MIL-M-28787/272A
AMENDMENT 2
31 March 1993
SUPERSEDING
AMENDMENT 1
20 December 1983

MODULES, STANDARD ELECTRONIC

CONVERTER, BCD/BINARY, DIGITAL, KEY CODE ZEZ

FIGURE 25. Power supply filter capacitance, input, and output capacitance test circuit for tables XVII, XVIII and XIX.

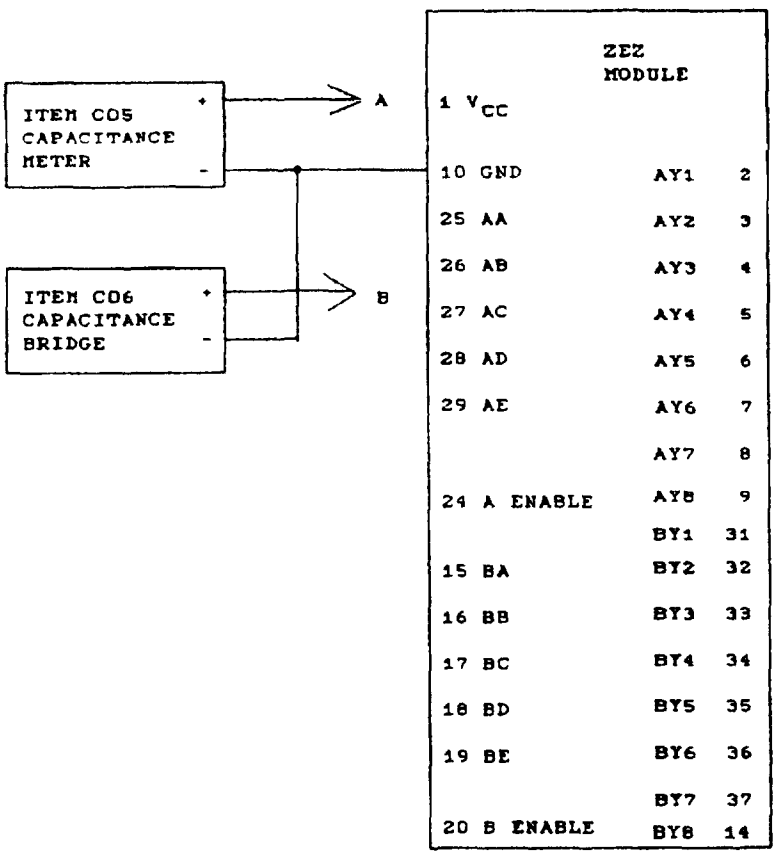
*FIGURE 25: Delete and substitute new figure 25 as printed on page 4 of this amendment.

1. Null out the effects of the test leads prior to connecting the module.
2. Do not attach test connector or wires to any of the module pins other than pin 10 and the pin under test. Stray capacitance added to other pins may affect the readings.
3. Item C06 setup: Frequency = 1 kHz.
   V_{pk} = 0.3 V maximum.
